UNITED STATES PATENT AND TRADEMARK OFFICE

APPLICATION NO.	FILING DATE	FIRST NAMED INVENTOR	ATTORNEY DOCKET NO.	CONFIRMATION NO.
09/806,941	05/21/2001	Ola Olofsson	TPP 31386	9543

Office Action Summary

Buzzella (figure 4 below) shows a joining profile having two upstanding lips disposed at

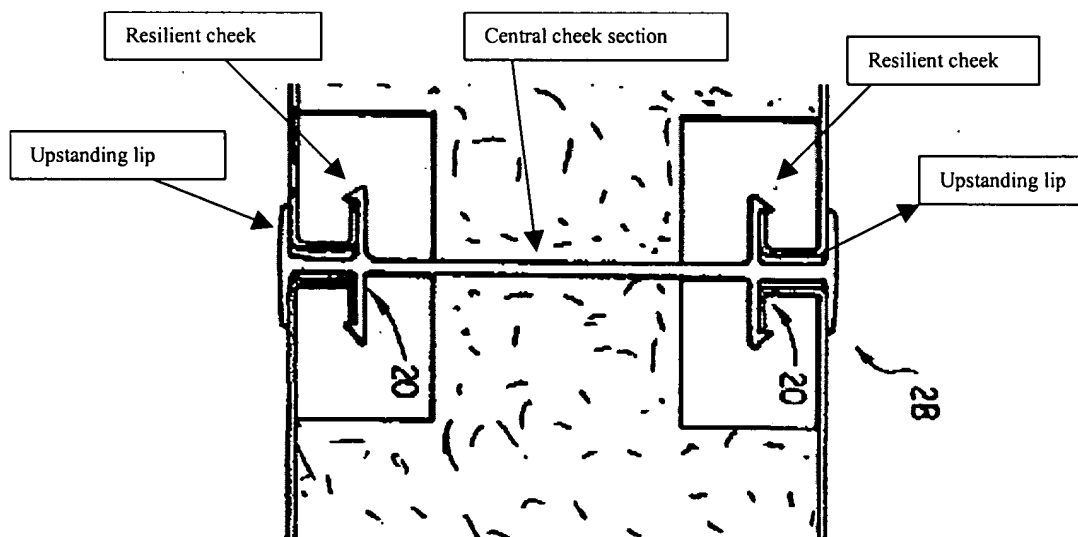
2. Claims 13-14 are rejected under 35 U.S.C. 102(b) as being anticipated by Buzzella (5062250).

opposite ends of and perpendicular to a middle section such that the middle section terminates with the upstanding lips, a central cheek section, the central cheek section having first and second resilient cheeks, each of the first and second resilient cheeks having a tongue extending perpendicular to the respective cheek (see above and col 3 lines 33-35 for resiliency), the first and second resilient cheeks being separated by a space (the horizontal span), the space large enough to permit deflection of one of the first and second cheeks without contacting the other of the first and second resilient cheeks.
